Subject: X15 CM2350 X114B/X116B Air Compressor Inlet Plumbing Sealing Improvement ATC

Number: Atc2405

**X15 CM2350 X114B/
X116B Air Compressor
Inlet Plumbing Sealing
Improvement ATC**

C. Seal the Turbocharger Inlet to the Turbocharger Adapter (Cont.)

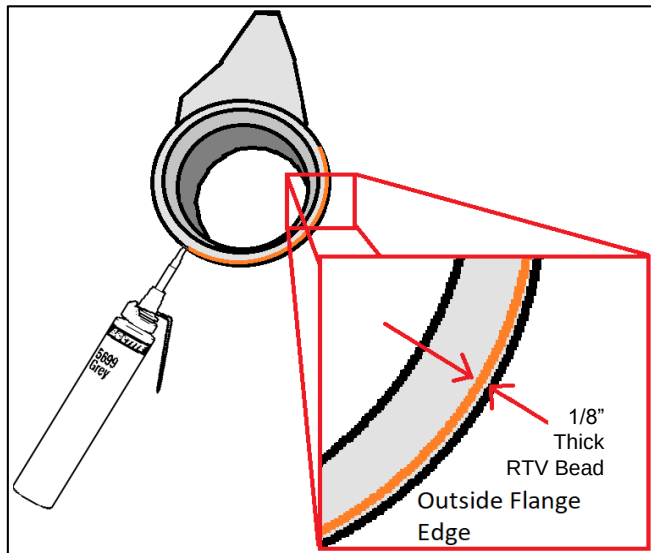
7. **Apply RTV** on the flat surface of the outside edge of the Compressor Adapter's rear face. Care should be taken for the following:

1. Bead must be no more than 1/8" wide along the outer diameter of the flange.
2. Assure the bead is both even thickness and even height.
3. Assure application of RTV is limited to the outside edge of the illustrated flange.

D. Air Compressor Inlet Plumbing O-Ring Installation

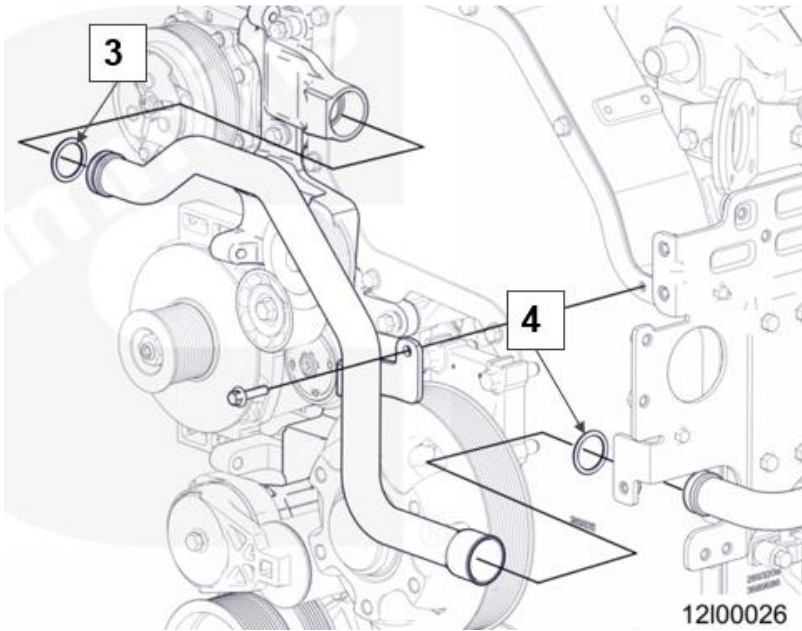
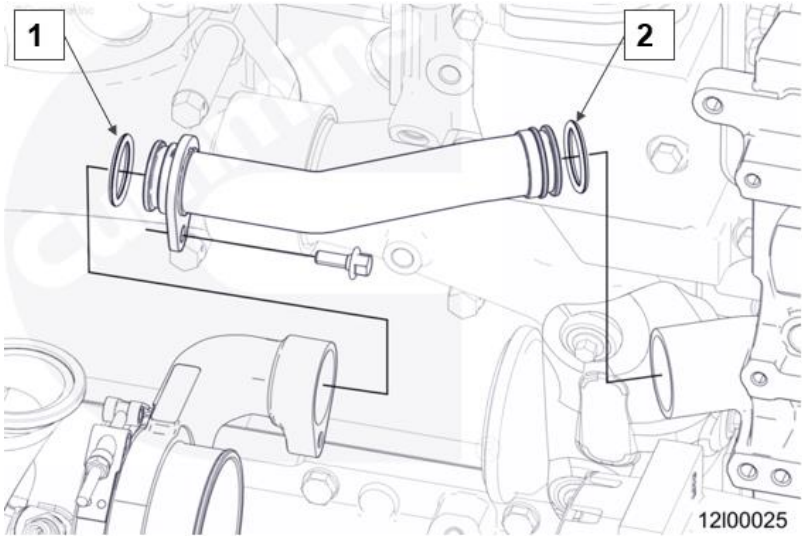
- Follow procedure 012-109 [Air Compressor Inlet Tube] in the applicable service manual and install 4 new O-Rings. Location of 4 O-rings shown in images to the right.
 - Before tube installation, apply P80™ Rubber Emulsion Lubricant (or equivalent) to the O-rings.

E. Replace Hose Clamp at Resonator Box

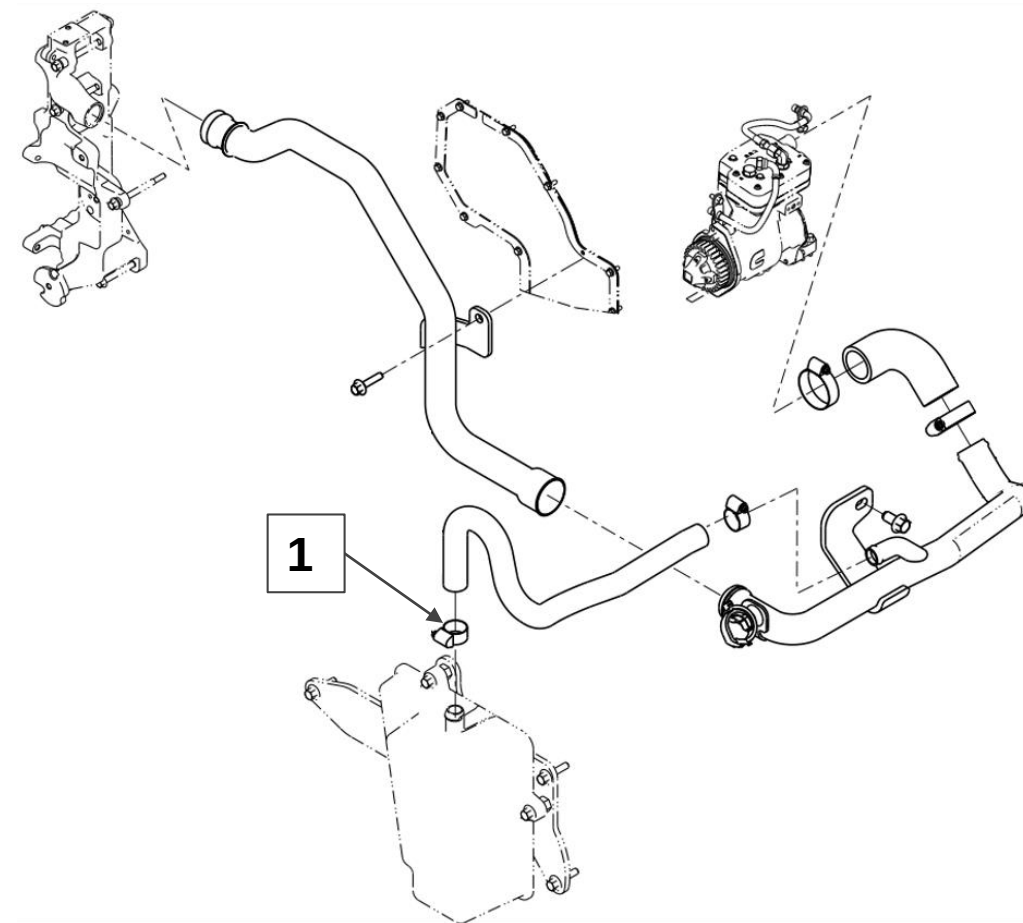
Replace the hose clamp at the resonator box with new constant tension spring clamp. Location of clamp indicated with #1 in image to the right.
